# The Rockeries and Hillside Park Landscape Study

## Public Consultation Report

February 2006

SENTIER ROCKCLIFFE PATHWAY - OPTIONS

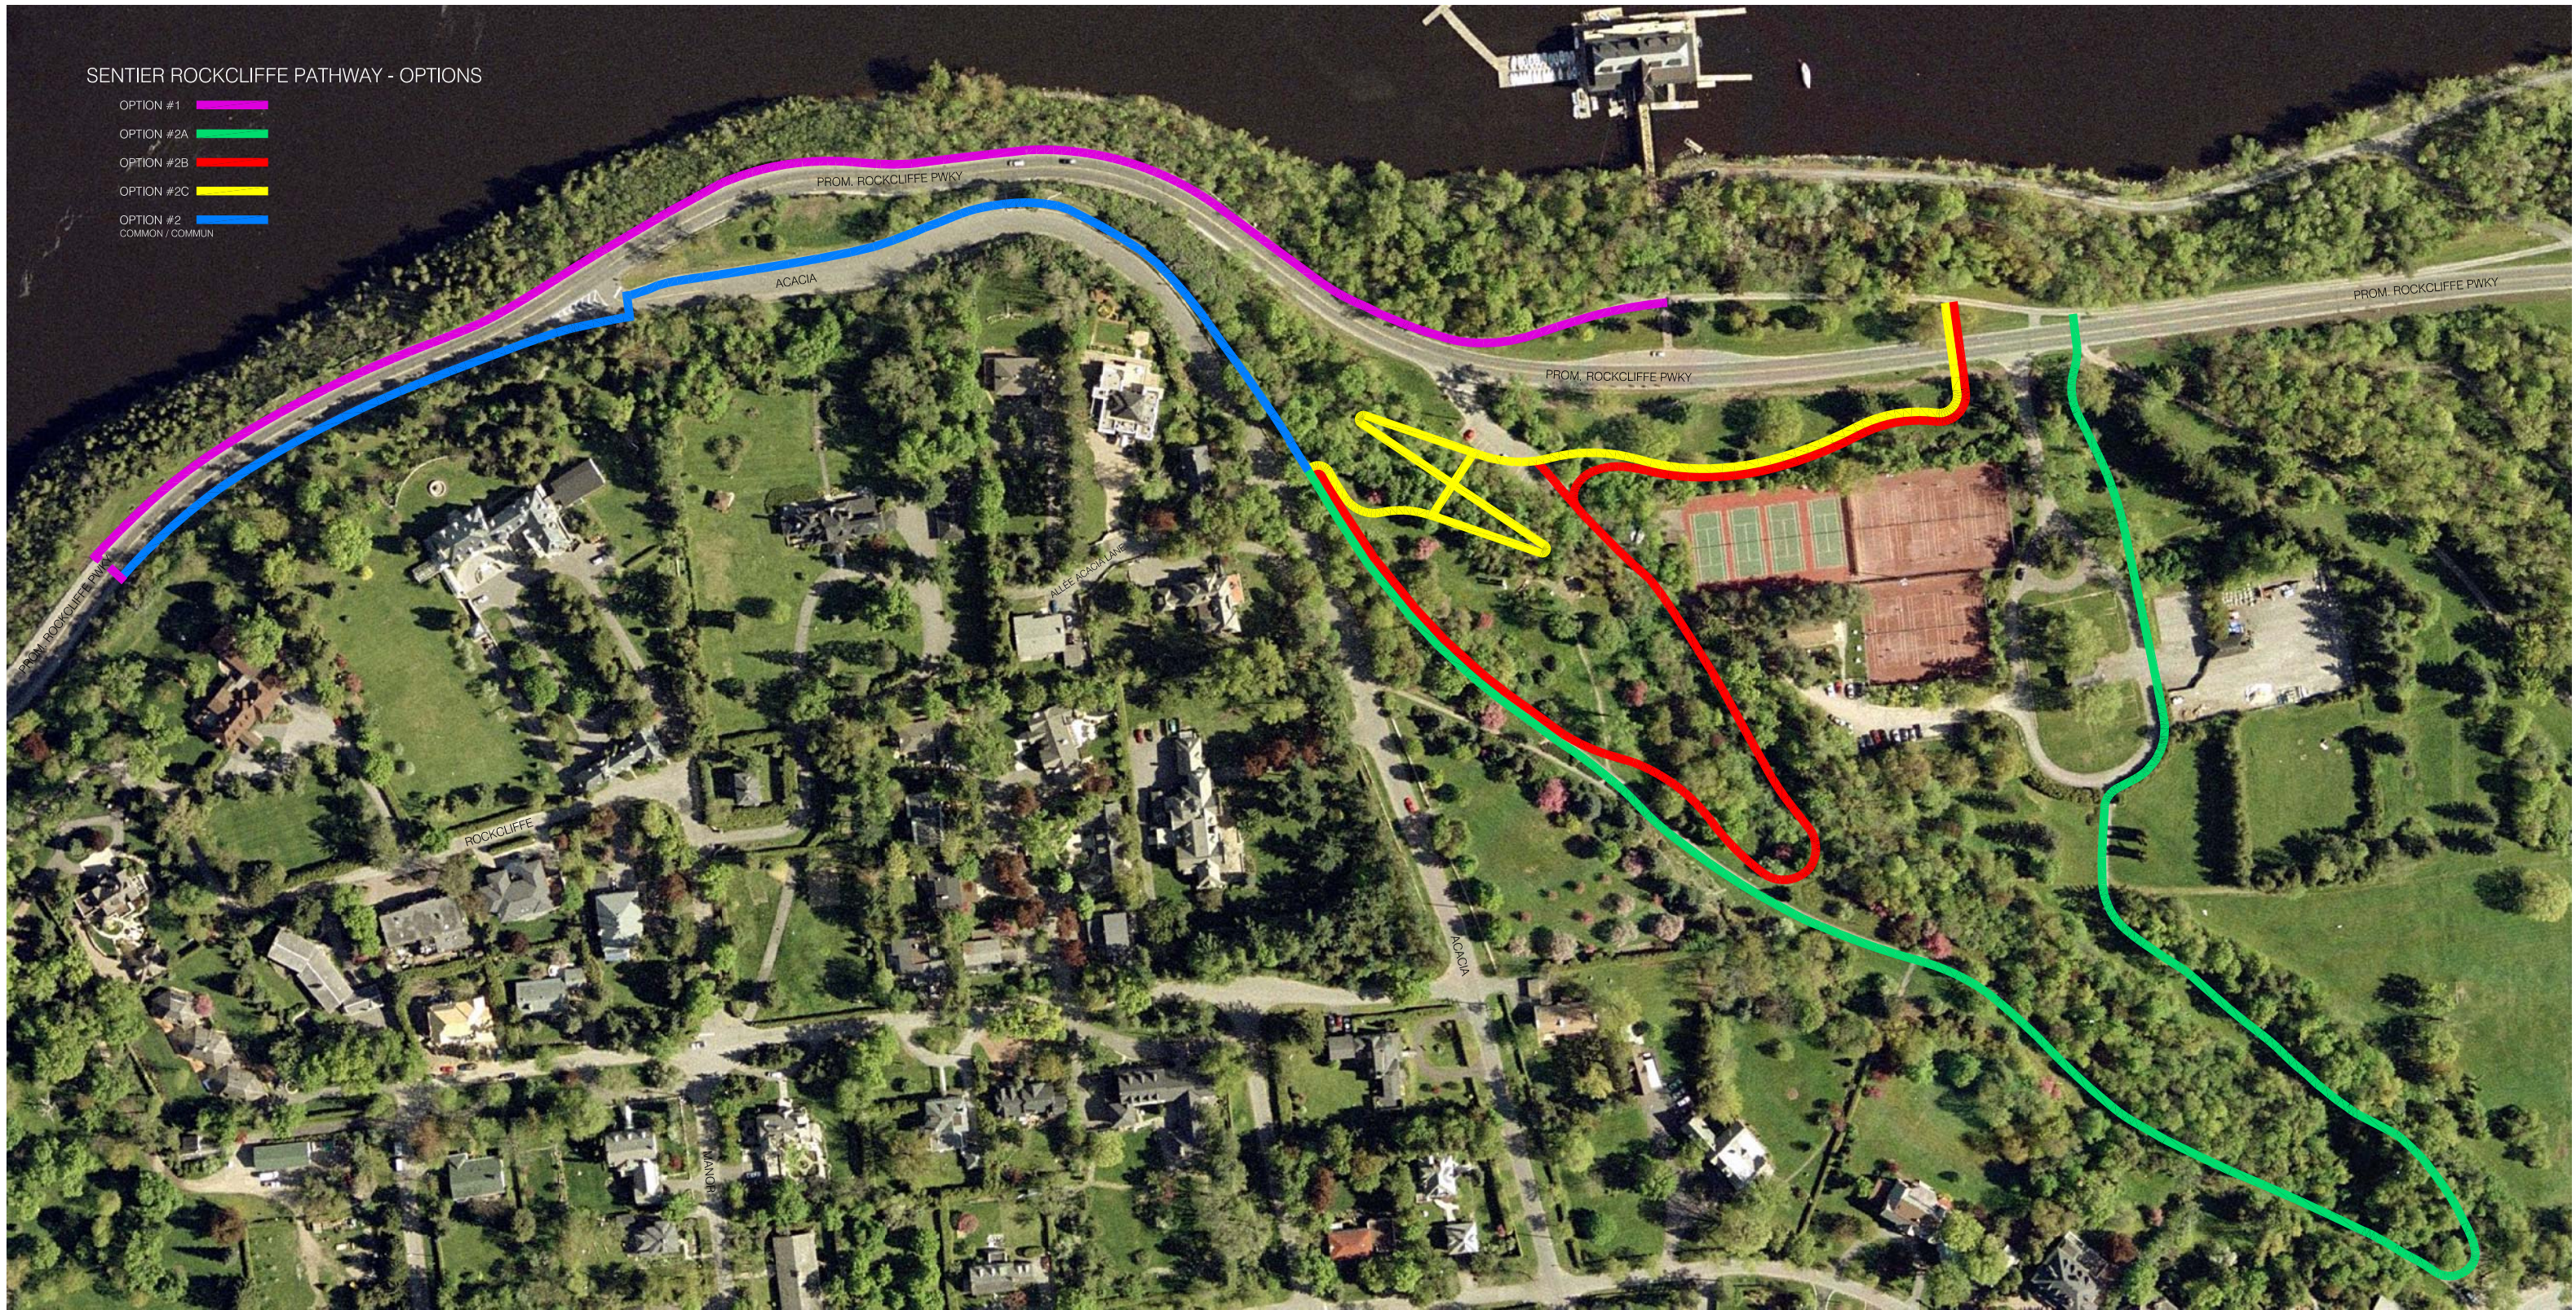
Magenta alignment is the preferred option.

Magenta alignment is the shortest route.

Magenta alignment gives a nice point of view on the River and Gatineau Hills.

Red option is the preferred option, it is safer than the magenta one and gives good access to tennis courts and canoe club (**Heritage Ottawa**).

Magenta alignment's cost is the same as the yellow (don't count the retaining wall in it).

Magenta alignment with a safer crossing at the east end would be the best option.

Red and yellow options will not be used by cyclists, too steep or too long.

Fisheries Act is a concern with the magenta alignment.

Preferred option is magenta, second is red.

As a result of this analysis, taking into account the public comments, the safety of users, the topography, the environmental impacts as well as universally accessible standards and the cost, the NCC identified the red option as the most viable option.

This option travels through the northwest corner of the Rockeries, an area consisting of approximately 10% of the 20 hectares Rockeries and associated open space lands. This option uses approximately 300 metres of an existing 2.5 metre wide asphalt pathway, before veering off and making use of an old road bed along the rock embankment and the roadside edge of the tennis courts. This option bypasses entirely the upper rock garden area, addressing any potential environmental impacts to the Rockeries area. See master plan in Appendix 1.

While many participants at the October 13<sup>th</sup> and 20<sup>th</sup> public meetings preferred the magenta option, a number of participants were supportive of the red option. There are some safety concerns with the magenta option, which would still require pathway users to travel a steep sloped, curving pathway beside a sloped, narrow and curving parkway. They would also be forced to cross the parkway in an area that is unsafe at the top of a hill. The construction of a pathway at this location would also have a considerable impact on the heritage character of the parkway, an important cultural landscape in the Capital, and would be the most costly solution because it requires the complete reconstruction of the retaining walls along the parkway.

As a result, in February 2006, the NCC adopted the red option as being the alternative that responds to the main concerns expressed during the public consultations and that satisfies the NCC's objectives for completion of a key missing pathway link, enhanced user safety, and offers an enjoyable experience to all users of the Rockcliffe Rockeries Park, a desirable destination for passive recreational purposes.
